Washington Public Power Supply System

Docket No. 50-508

September 8, 1983
G03-83-720

Subject: NUCLEAR PROJECT 3
RESPONSES TO NRC SAFETY EVALUATION QUESTIONS

FIG. 1 STRUCTURAL MODEL

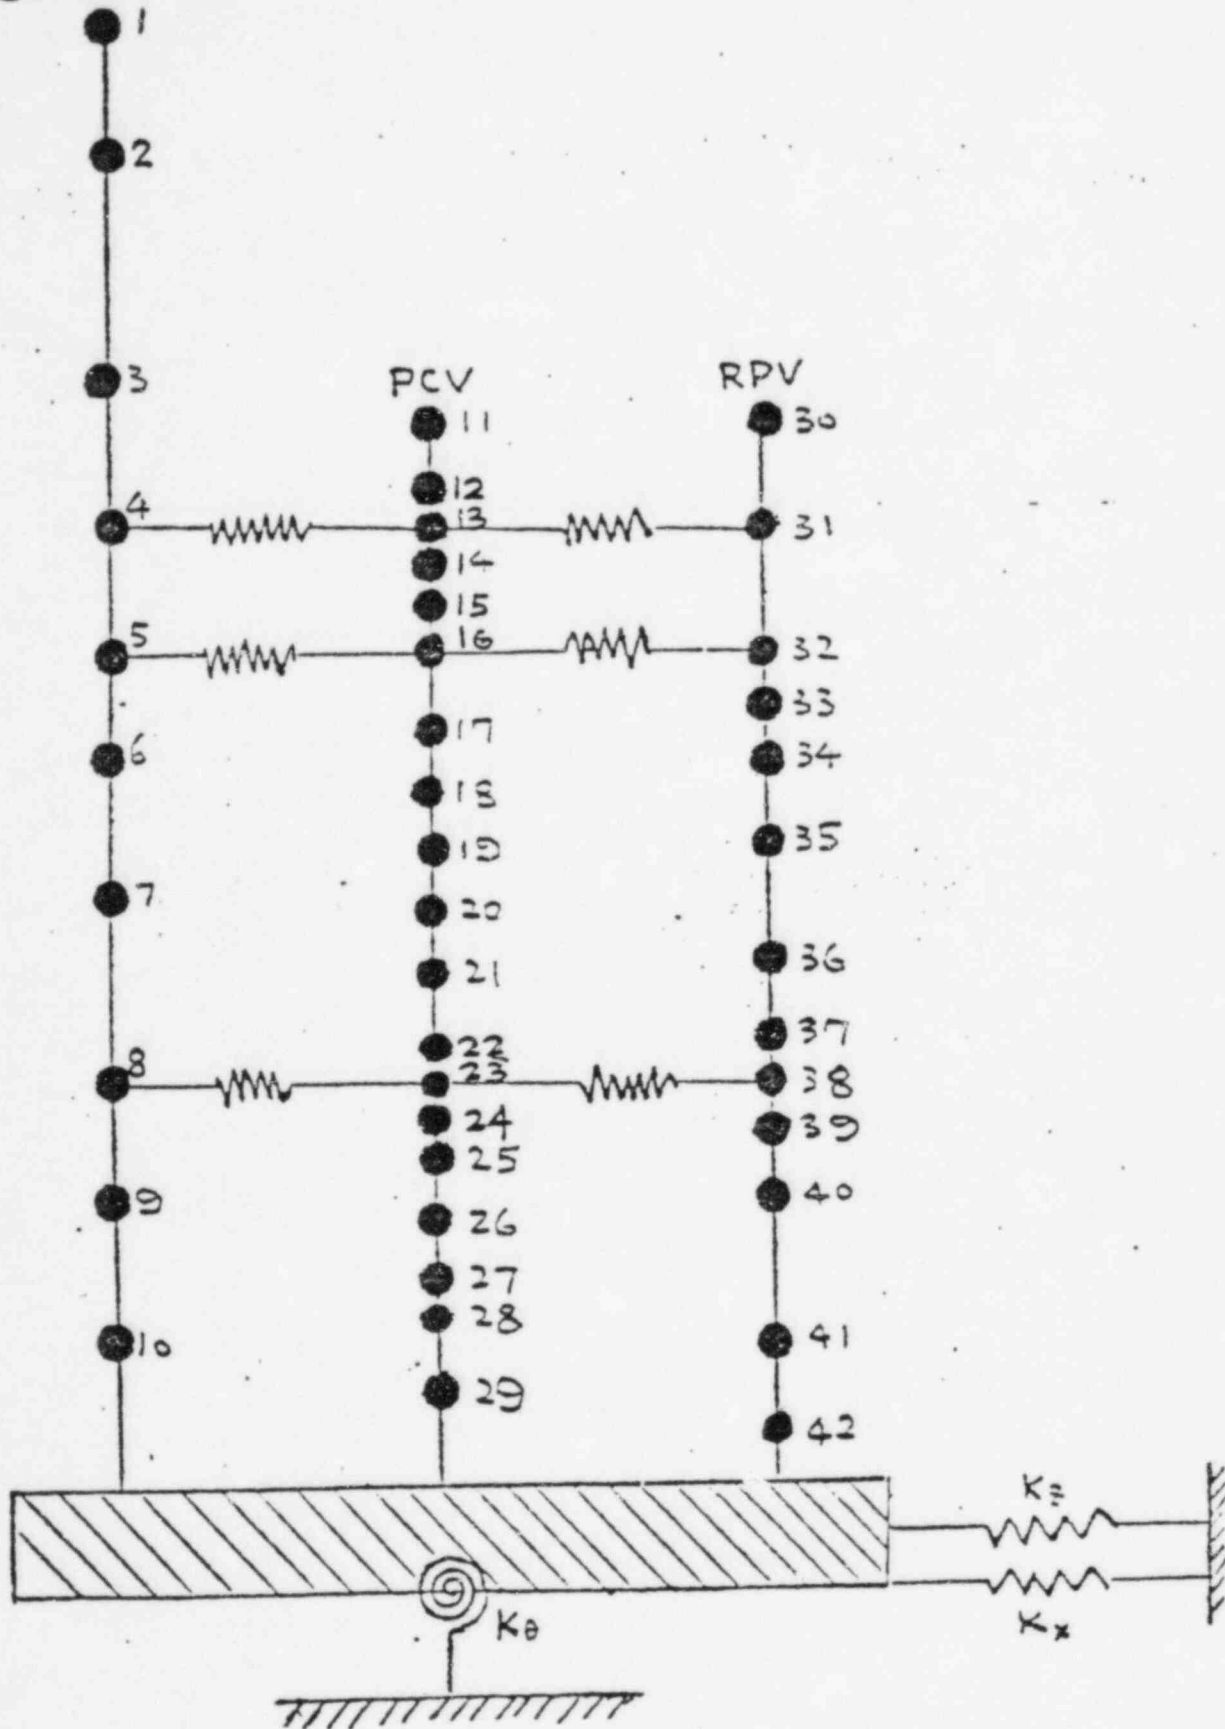
220.14 Provide a tabulation of all computer programs used in these (SRP 3.8.1, sections. Include descriptions and validation information. II, 4, e The staff position is described in NUREG-0800 (SRP) Section (for re- 3.8.1, II, 4, e. ference)
 FSAR 3.7.1,
 3.7.2,
 3.7.3,
 3.8.3,
 3.8.4,
 3.8.5)

DYNAMIC 2037 is an EBASCO in-house computer program which operates on BURROUGHS-7700 and solves seismic dynamic problems by time history modal-response method. Since this program is not a recognized program in public domain, a comparison of it with STARDYNE (version 4/1/72) is made here to demonstrate its validity and applicability.

A typical reactor building is used in this comparison and the dynamic structural model of this building is shown in Fig. 1. The seismic time history used is Elcentro NS 1940 normalize to 0.18g.

Natural frequencies for first ten modes, maximum displacements, forces, shears and moments at selected mass points or numbers output from both DYNAMIC 2037 and STARDYNE are tabulated in TABLE I, II, III, IV and V respectively. These almost identical results validate DYNAMIC 2037 for type of problem stated here.
